SEWAGE DISPOSAL SYSTEM

MARYLAND STATE DEPARTMENT OF HEALTH

SUBDIVISION Charterville Ridge 6719 Hitching Post Court

6719 Hitching Post Ct.
Clarksville, Md 21029
Lot 24 Section 24

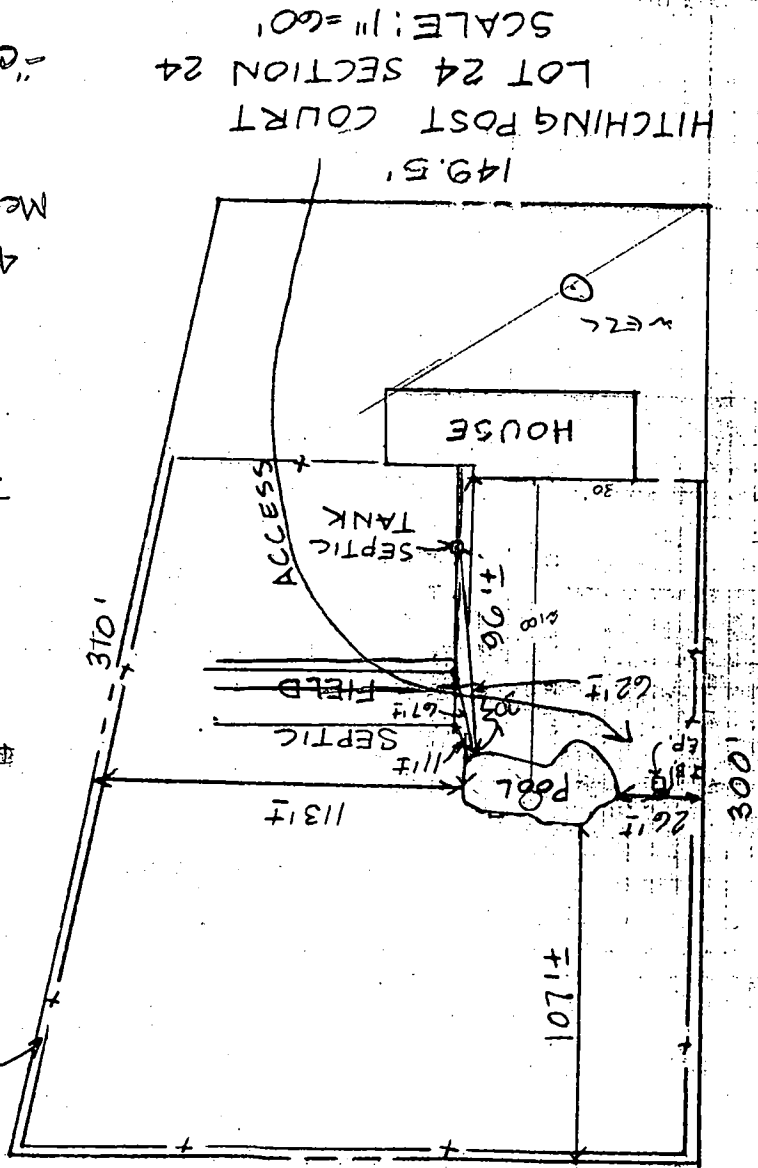
Site inspection

Possible septic cleanup
found 30' from rear edge
of hose 4' out - doesn't
match septic records - cleanup
appears to be a drywell
and not the trench system
shown in records.
If it actually is septic cleanup -
then it is in the middle of
the pool

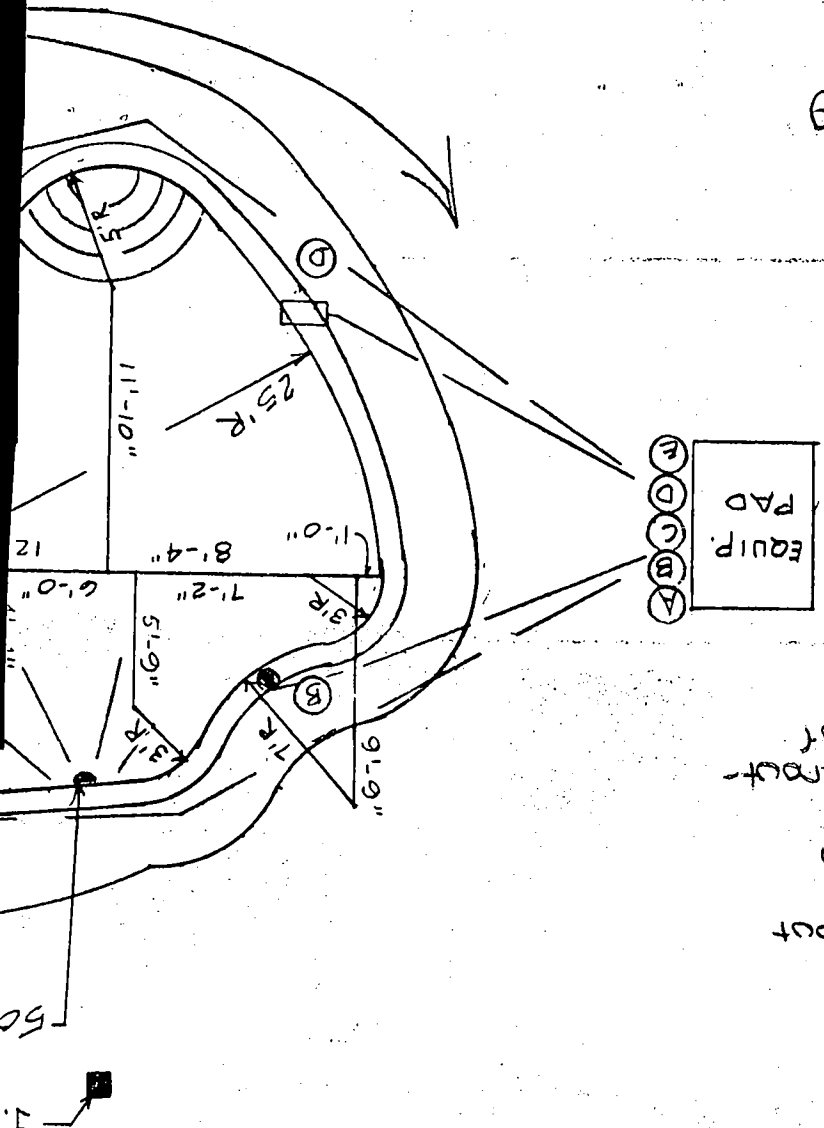
Met owner on site - septic
actually located as
shown in red on this
plan

"cleanup" observed on
1st inspection is not a
cleanup - it is a
spicket for water in
pool location will have
no impact to the existing
well or septic

NOTE: Repairs to be made
higher than existing
drainfields due to
a leach support

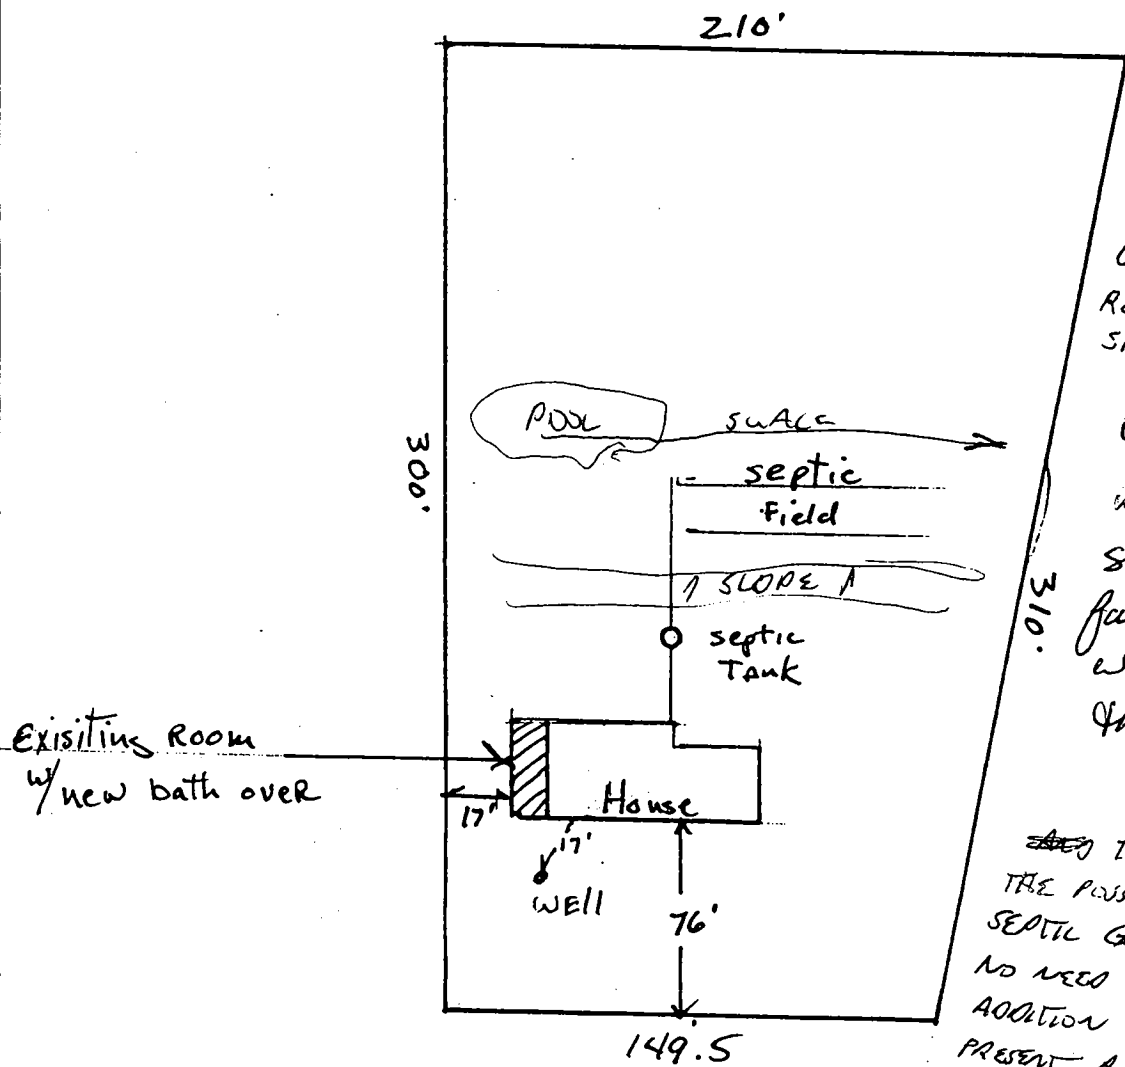
6/30/97
BPI NO EVIDENCE OF
SEPTIC CLEANOUTS, OR OF
DISCHARGE, LOT IS UNOCCUPIED
REPAIR AREA EXISTS ON LOT
SINCE OWNERS HAVE THE MEANS

~~AND~~ TO FIX SEPTIC AND
THE POSSIBILITY OF A FAILING
SEPTIC GOING UNNOTICED IS SLIM
NO NEED TO HOLD PERMIT.
ADDITION DOES NOT APPEAR TO
PRESENT A SIGNIFICANT INCREASE
TO SEPTIC. WELL LOCATION OK

6/30/97
We understand the septic
system is old and could
fail in the near future. We
will fix promptly when
this happens.
